Groundwater Application Review Summary Form

Application # G- 18545

TO: Water Rights Section Date November 17, 2017
 FROM: Groundwater Section Aurora C Bouchier
Reviewer's Name
 SUBJECT: Application G- 18545 Supersedes review of na
Date of Review(s)

A. GENERAL INFORMATION: Applicant's Name: CPM Development Corp County: Marion

Water-Level Trends in Nearby Wells

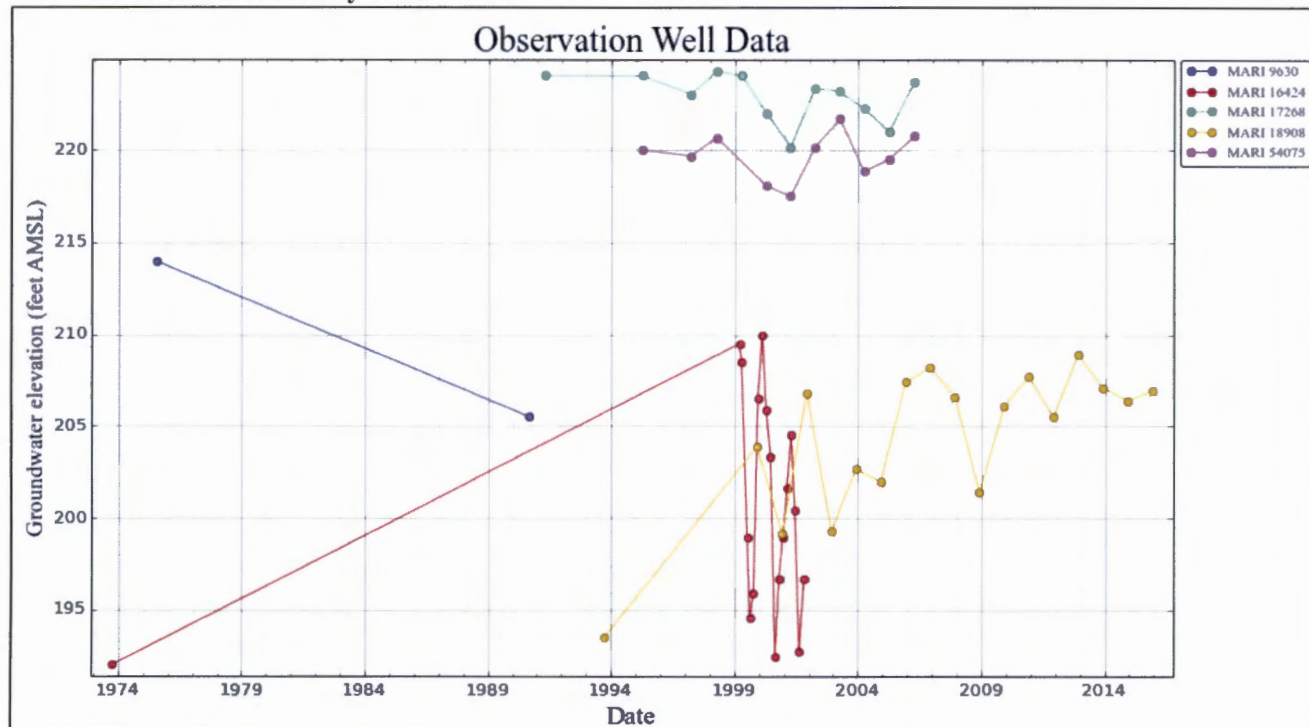
B3. **Groundwater availability remarks:** About 100-140 feet of saturated gravels occur in the vicinity of the subject wells (Gannett and Caldwell, 1998). Nearby observation wells show stable water levels since at least the mid-1990s. The great saturated thickness, the unconfined nature of the system, the lack of intense development in the area, and stable water levels indicate that additional development should be available within the capacity of the ground-water resource.

Stream Depletion

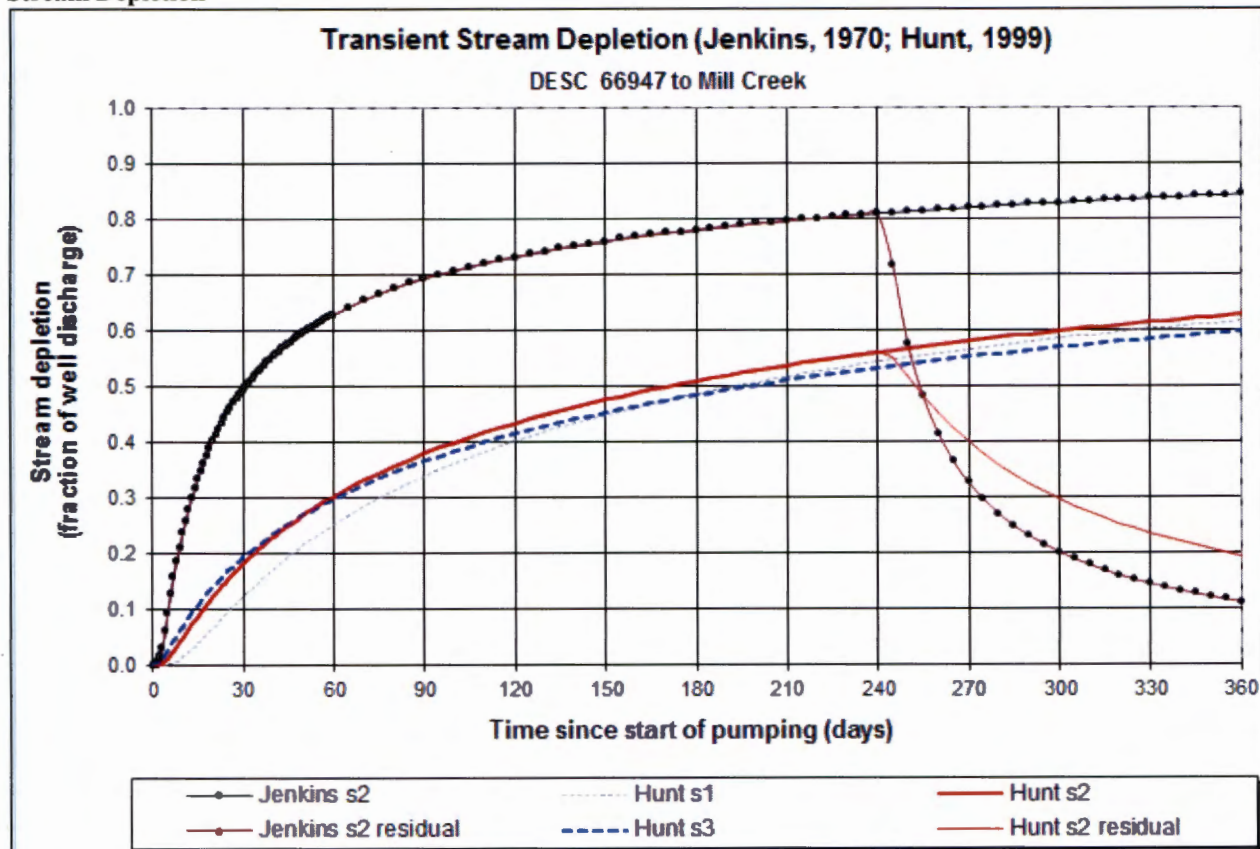
Comments: Stream depletion was estimated using the Hunt 1999 model (see attached plot). Impacts to Mill Creek due to pumping from the well are likely to less than 25% after 30 days. The model parameters utilized a range of reasonable hydraulic conductivities for Holocene gravels and a very conservative streambed hydraulic conductivity of 1 feet per day – equivalent to a silty sand.
